MEMORANDUM FOR: Commissioner Gilinsky
FROM: William J. Dircks
Executive Director for Operations
SUBJECT: SHOREHAM ECCS

Safety Evaluation Report

related to the operation of
Shoreham Nuclear Power Station,
Unit No. 1

Figure 2.3.18 Comparison of the HEPs Associated with Operator Actions for Singular Events and Coincident Multiple Events

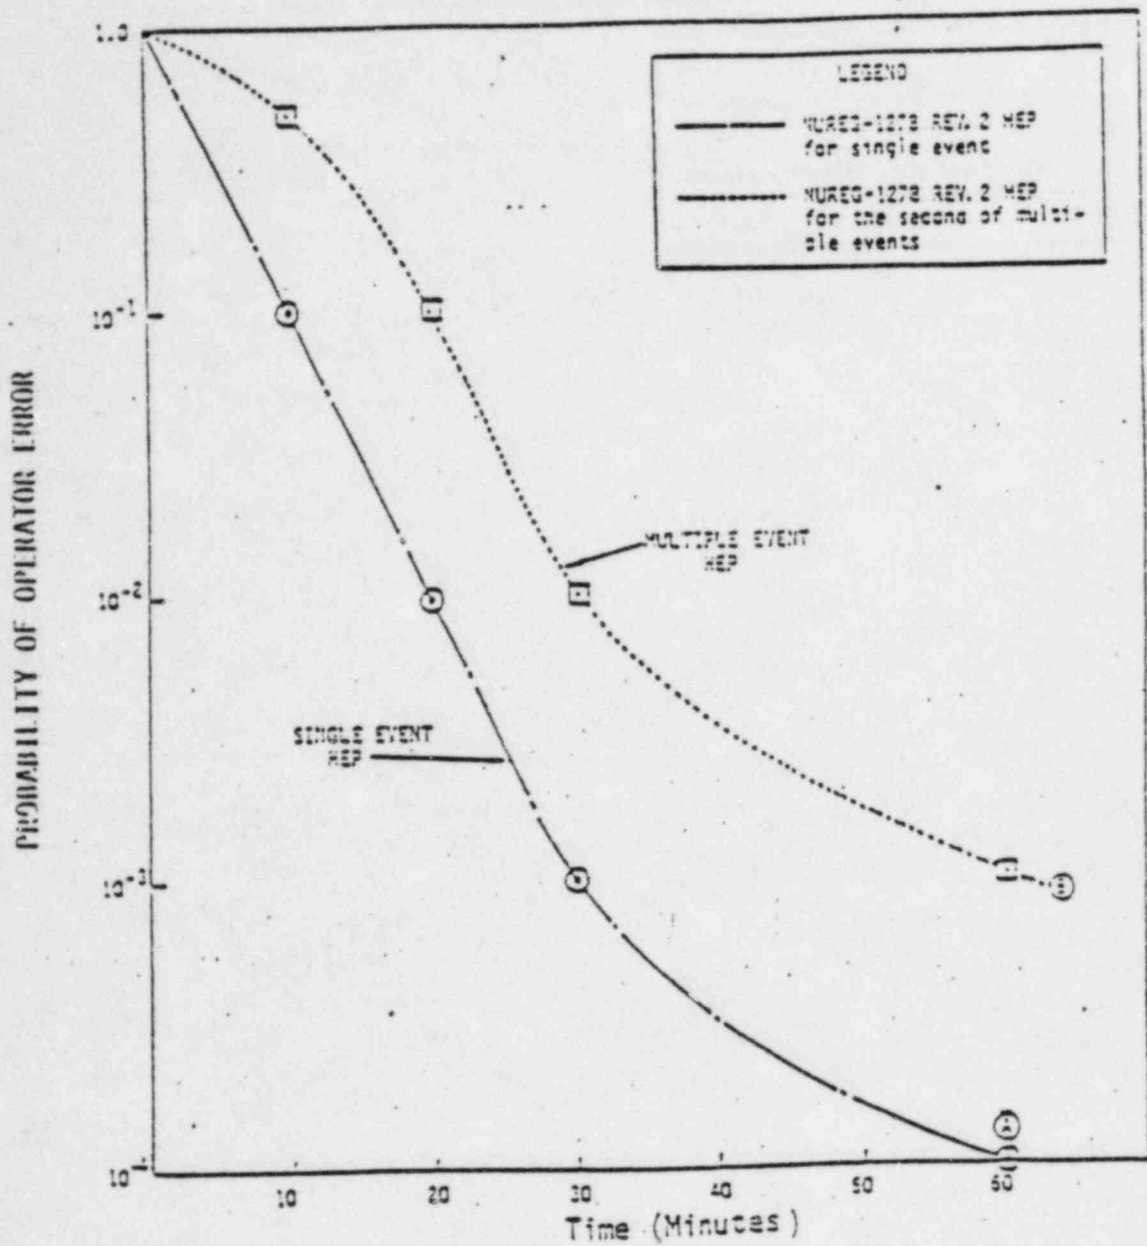
The HEP values used by SNPS are identical to the nominal HEP values provided in the Probabilistic Risk Analysis Procedure Guide (see Figure 3.2.1 and Table 3.2.3). BNL feels that the HEP could be higher than the nominal HEP values because the flooding alarm related procedures fail to provide specific guidelines to identify and to isolate the flood source (see Section 3.2.1).
